COMPREHENSIVE MONITORING PROGRAM

FINAL TECHNICAL PLAN

GROUND WATER

PAGE
9.0 HEALTH AND SAFETY	67
9.1 Introduction	67
9.2 Responsibilities	67
9.2.1 Health and Safety Supervisor (HSS)	67
9.2.2 Ground-water Monitoring Personnel	67
9.3 Hazard Assessment	68
9.4 Personal Protective Equipment	69
9.5 Decontamination	69
9.6 Emergency Procedures	70
10.0 REFERENCES	71
11.0 ADDENDUM	72
12.0 RESPONSES TO COMMENTS ON THE NOVEMBER 1988 CMP DRAFT FINAL TECHNICAL PLAN	74

FIGURE 1.1-2

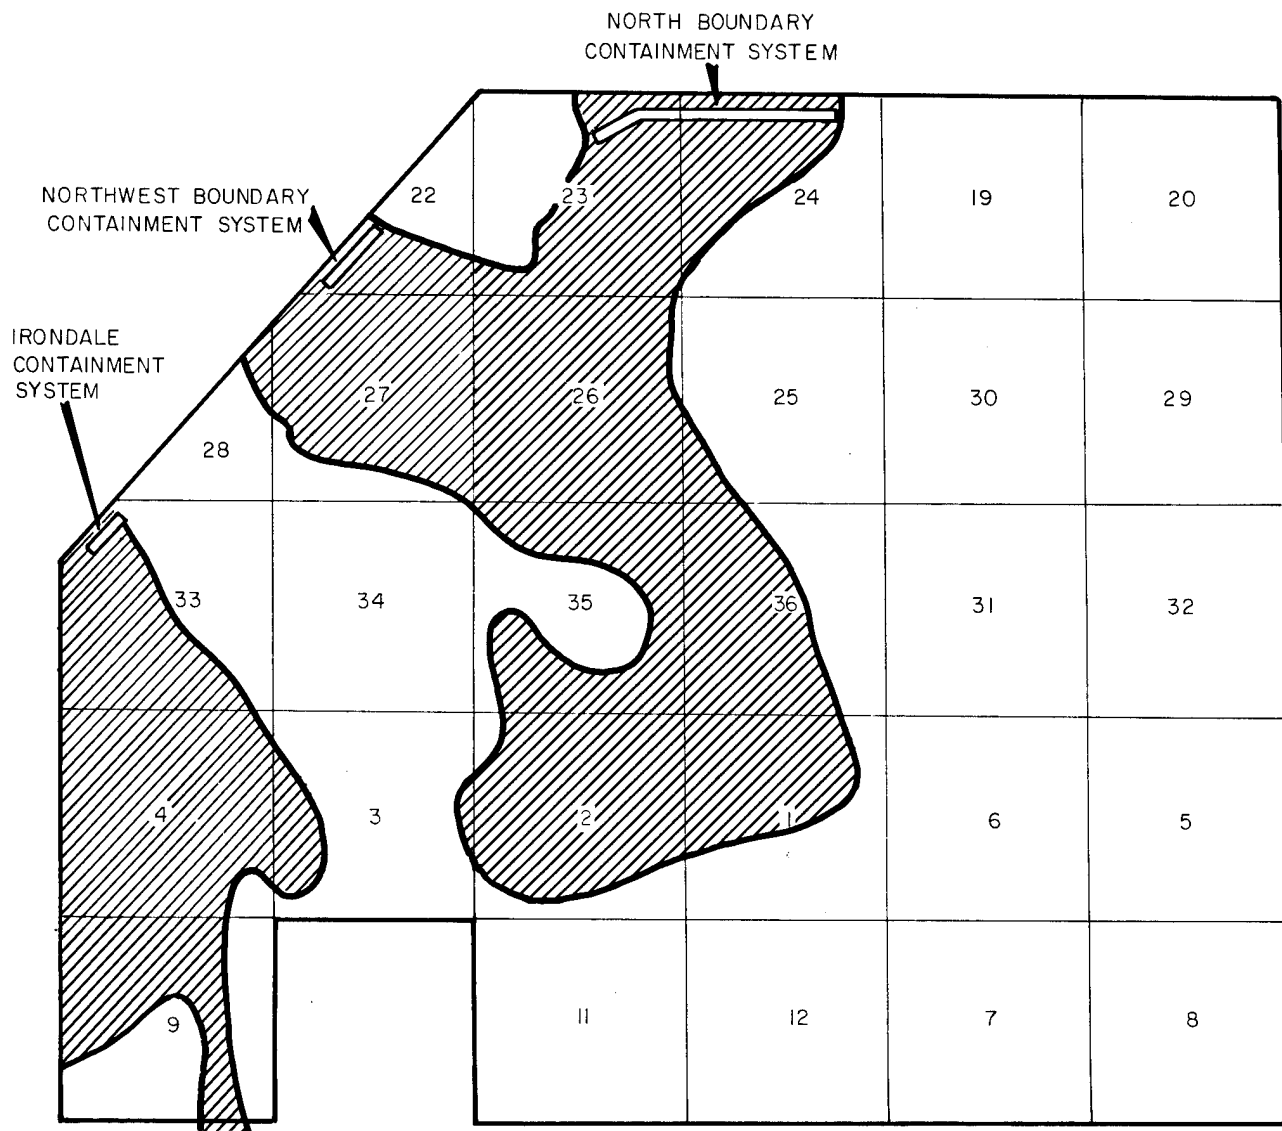
For consistency with the second full paragraph on page 3, solid waste disposal areas and the chemical sewer system should be shown in Figure 1.1-2.

Response: Figure 1.1-2 will be revised accordingly.

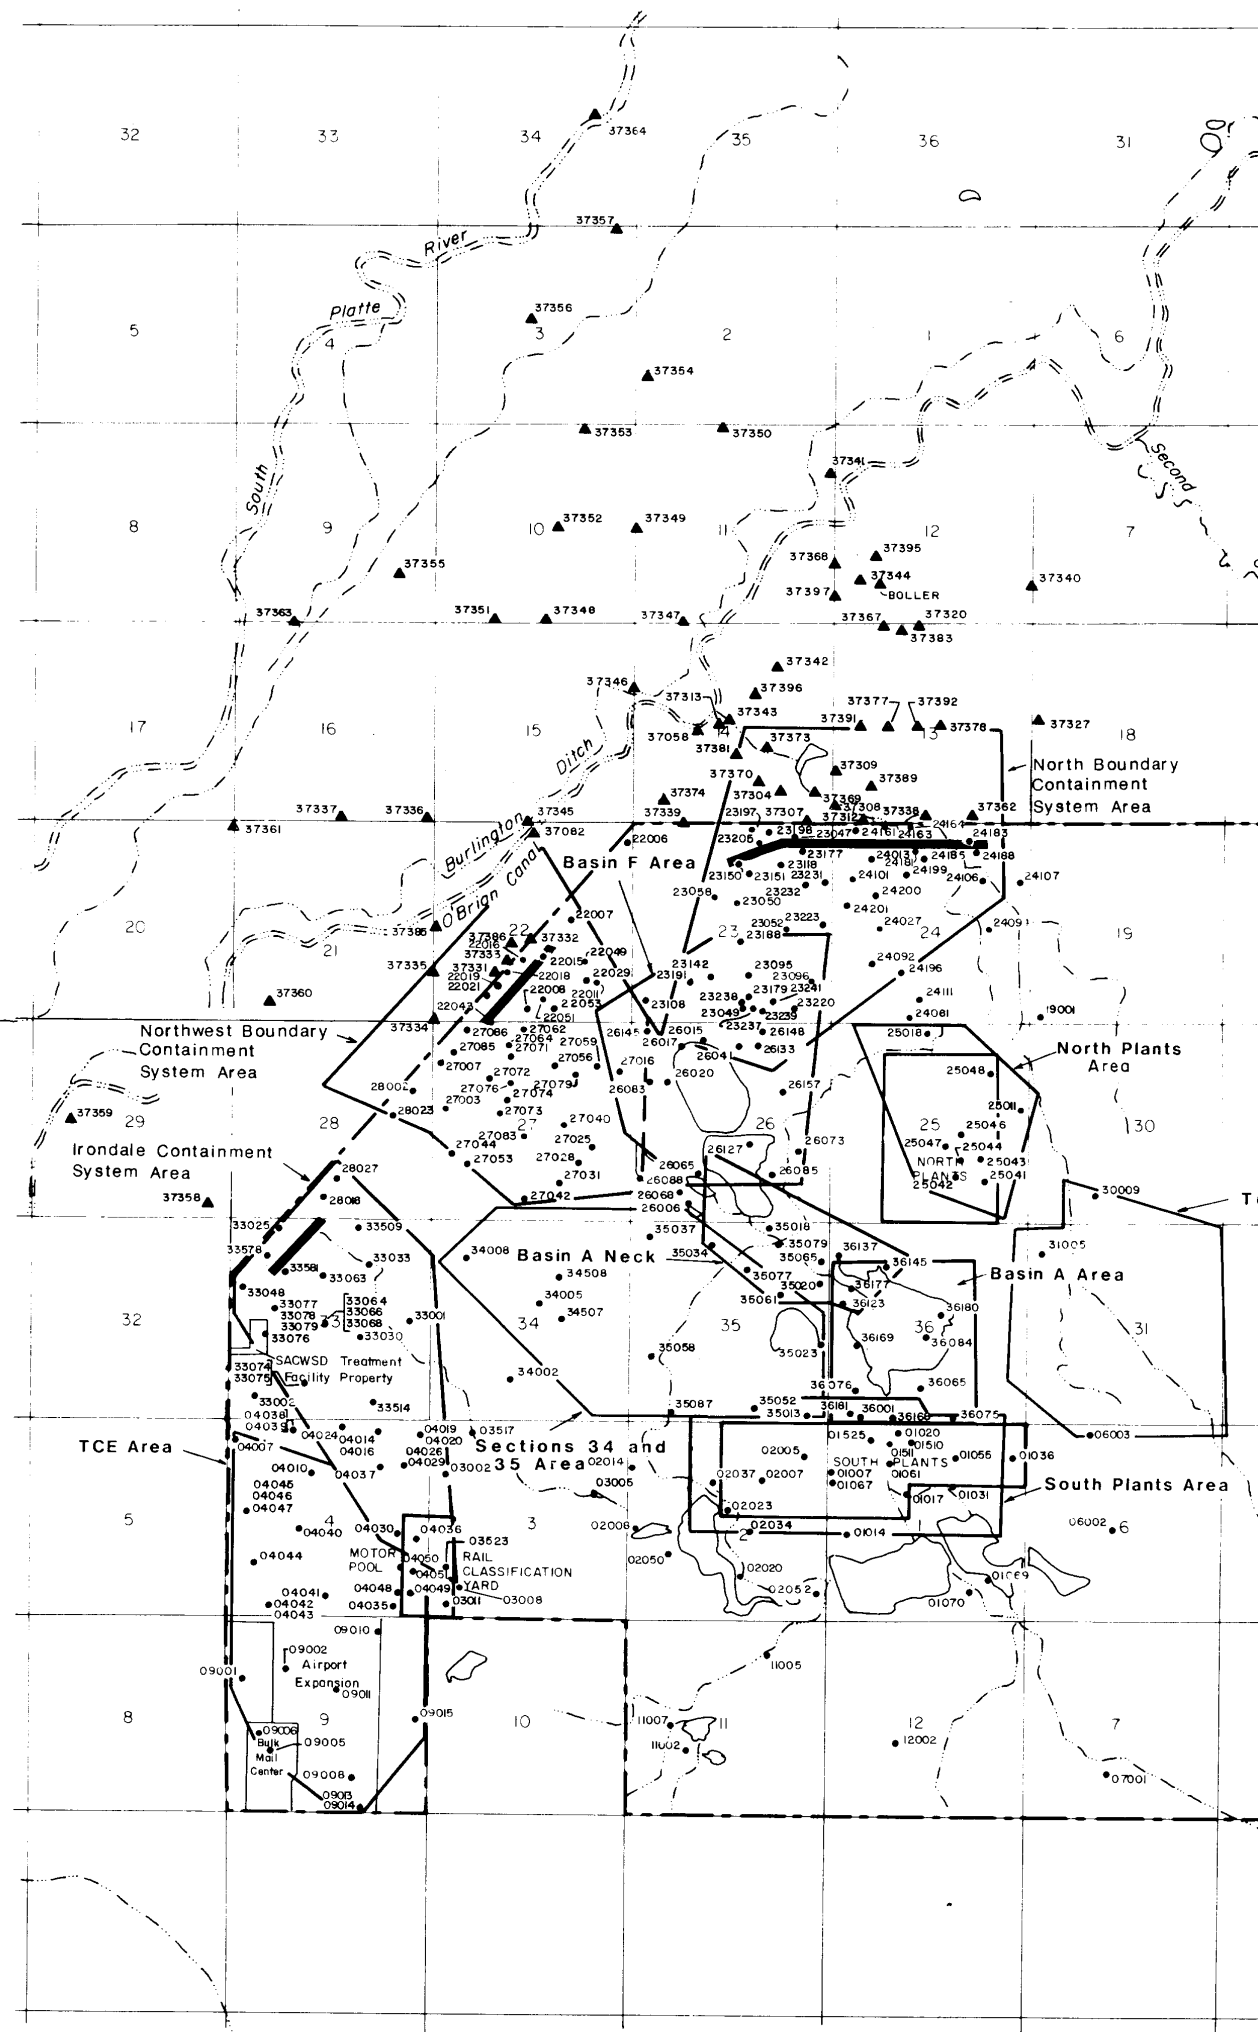
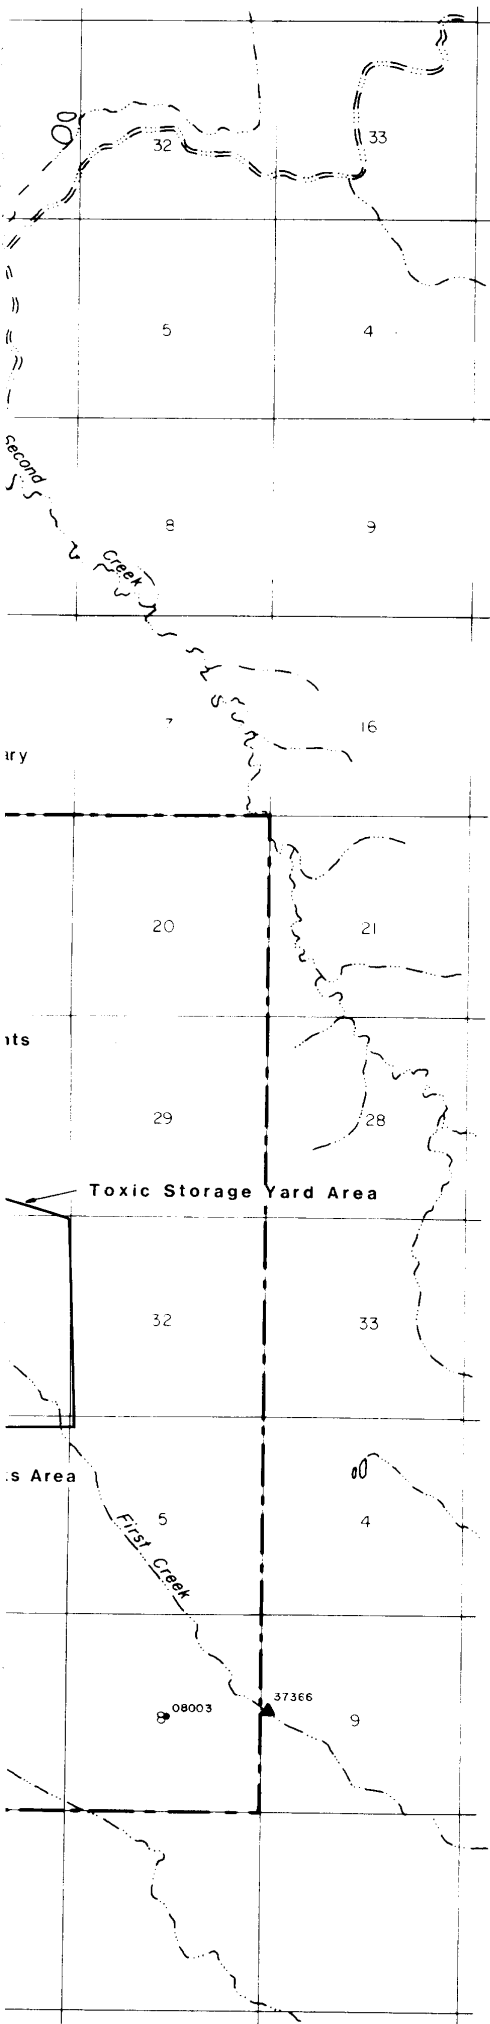
Comment 13. **Pgs. 46-51 and Plates 2.3-1 and 2.3-2** - All additional wells to be included in the program should be added to the appropriate lists and Plates. Well 24136 is missing from Plate 2.3-2. Well 26061 is included on Plate 2.3-2 but not on one of the lists.

Response: The Draft Final CMP Technical Plan, Plates 2.3-1 and 2.3-2 present wells that comprise the annual monitoring-well network. The wells mentioned in the Plates for the semi-annual or quarterly monitoring-well networks were not included in this plan. Modifications to any of the monitoring networks will be reflected in revised lists and Plates. The errors identified have been noted.
